2020 Corvette: Service Bulletin:: #20-NA-179: Malfunction Indicator Lamp (MIL) Illuminated - DTCs P0521 and/or P06DD Set - (Oct 23, 2020)

Subject: Malfunction Indicator Lamp (MIL) Illuminated
– DTCs P0521 and/or P06DD Set

Brand:	Model:	Model Year:		VIN Breakpoint:		Engine:	Transmission:
		from	to	from	to		
Chevrolet	Corvette	2020	2020	SORP	September 10, 2020	6.2L (LT2)	—

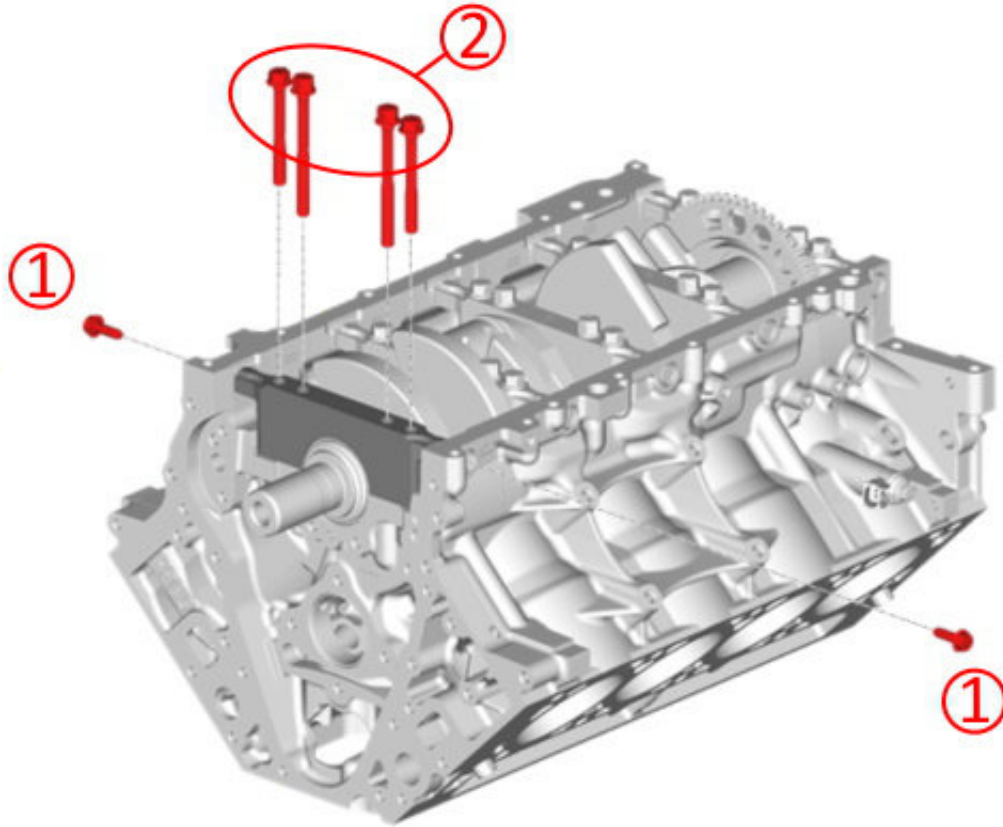
If P0521 and P06DD DTCs are present, then a redesigned oil pressure control valve retainer clip (1) may be necessary. Refer to the Service Procedure section below.

1. Remove the engine oil pan. Refer to *Oil Pan Replacement* in SI.

Note: The generator may need to be repositioned to gain access to the main cap side bolts.

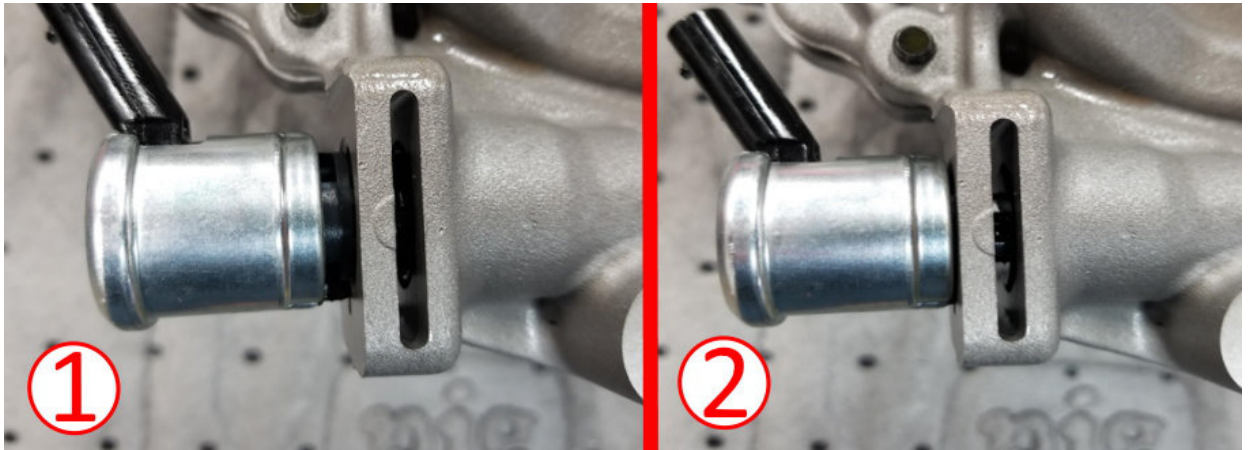
1. Remove the main cap side bolts (1).

Important: When removing the main bearing cap be careful not to damage the main bearing or journal surface of the crankshaft. Please set the main bearing cap in a safe place so no debris or damage could occur.

1. Remove and discard the bolts (2) that secure the #1 main bearing cap.

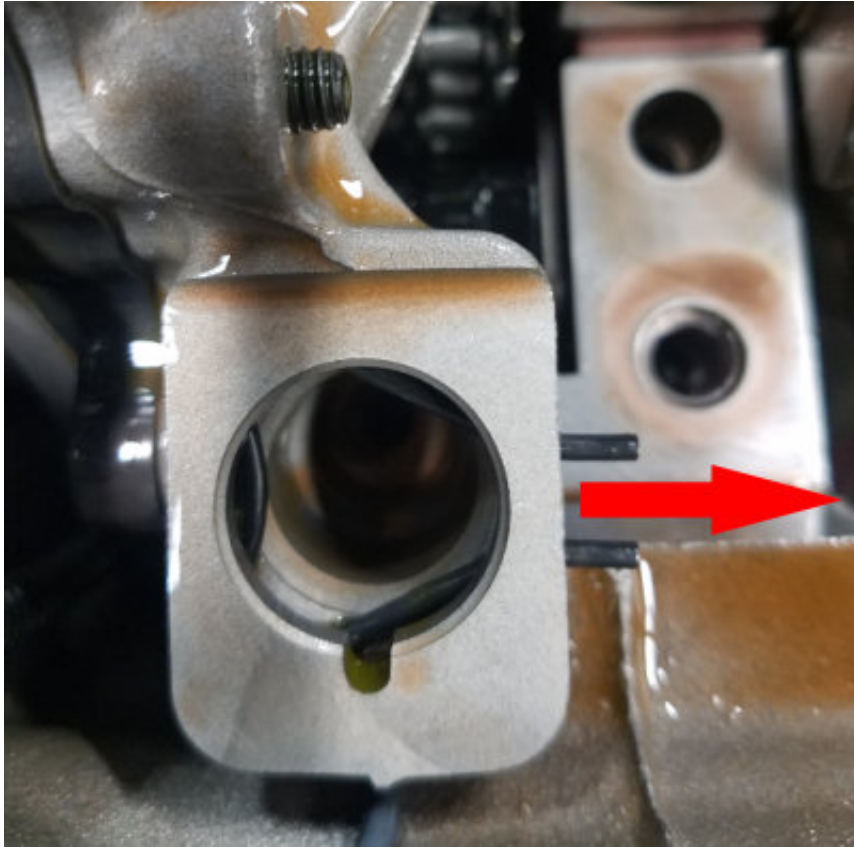
1. Inspect the OCV:
 - If you find this oil pressure control valve dislodged (1), it will be necessary to install a redesigned oil control valve retainer.
- Disconnect the oil pressure control valve electrical connector and position aside.

Note: Remove the existing oil pressure control valve retainer by pulling towards the rear and discard. You will be installing a newly designed retainer during installation.

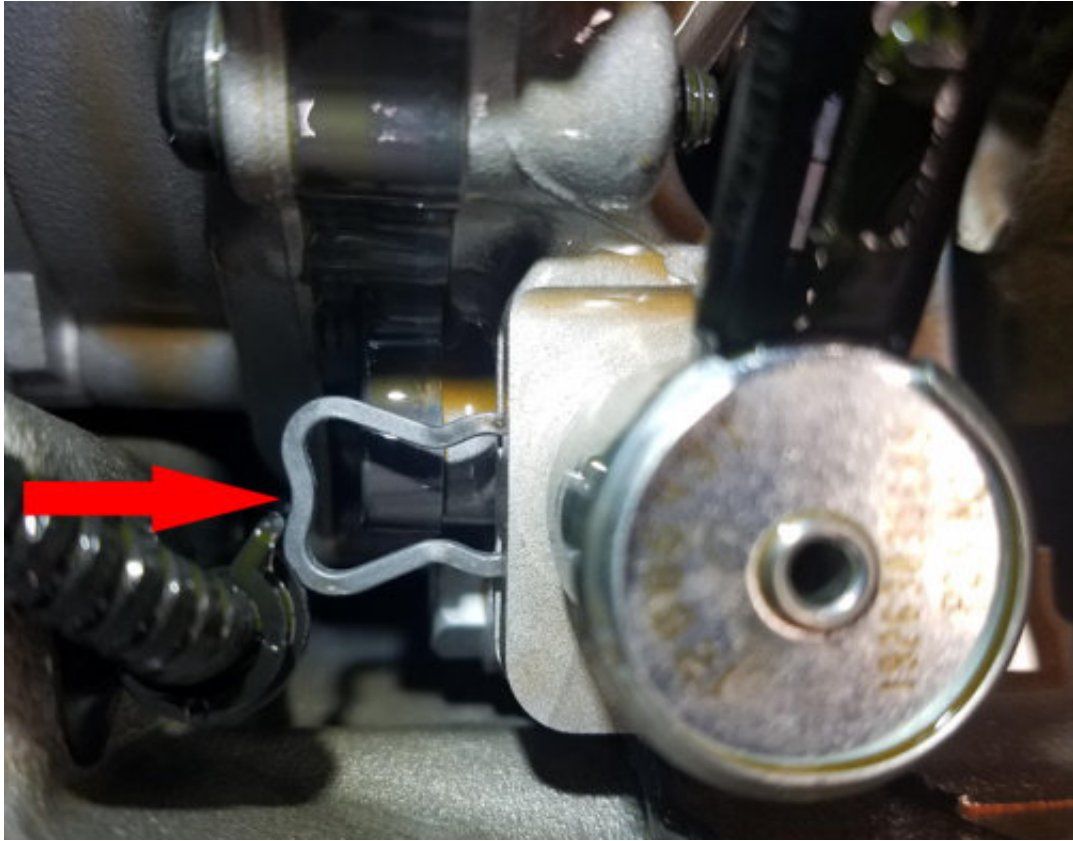
1. Push in the retainer and remove the oil pressure control valve and set aside.
 2. Once the retainer is removed, inspect the oil pressure control valve for any signs of damage and ensure the O-ring is not cut.
- Apply a small amount of clean engine oil to the pressure control valve and reinstall ensuring it is seated correctly.

Important: Do not use any tools to tap the pressure control valve into place. Only install the pressure control valve by pushing on the body of the valve by hand.

1. Install the new retainer from the front of engine towards the rear as shown in the graphic above.

1. When the retainer is installed, there should be about 2 to 3 mm of clearance between the retainer and the oil pump body as shown above.
 - Ensure the pressure control valve and retainer are correctly installed.
- Ensure the cap and bearing are VERY CLEAN and apply assembly lube prior to installation.
- Install the front main bearing cap with new bolts.
